City Unified School District

ADDENDUM NO. 1

Date: February 17, 2017

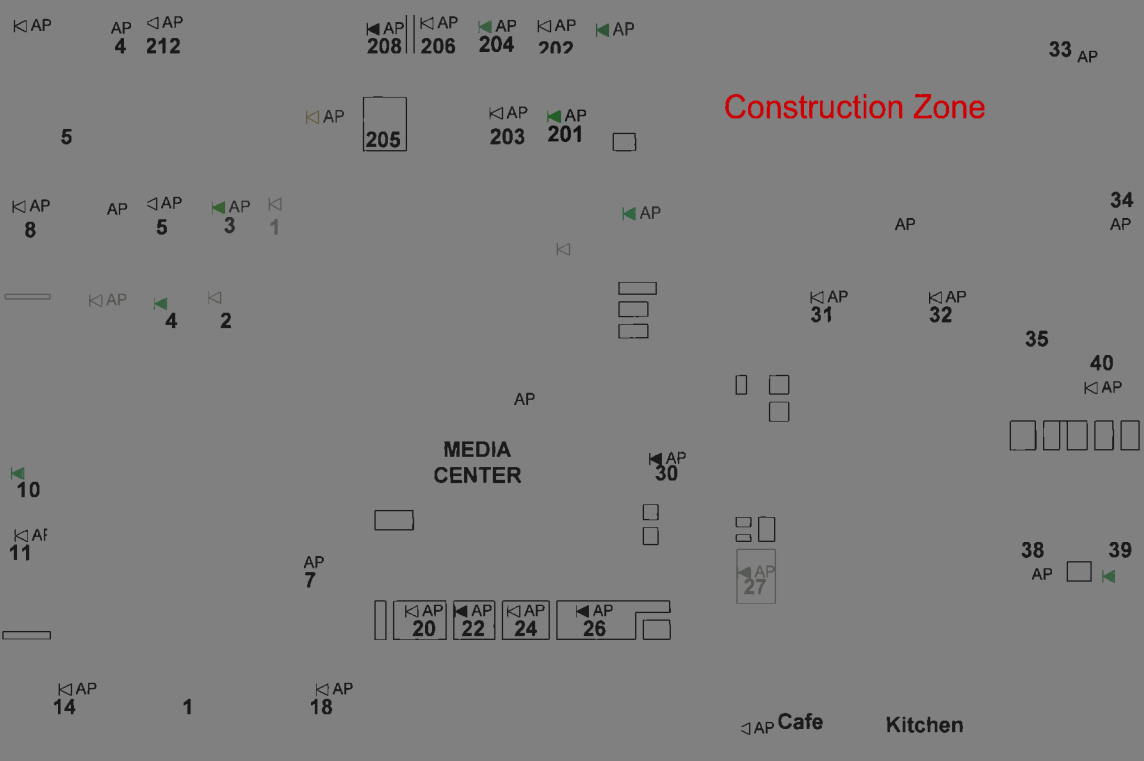
1.2.1.22.3.1.5 No exposed conduit, on the interior of
the building, unless approved by the

Owner, prior to installation.
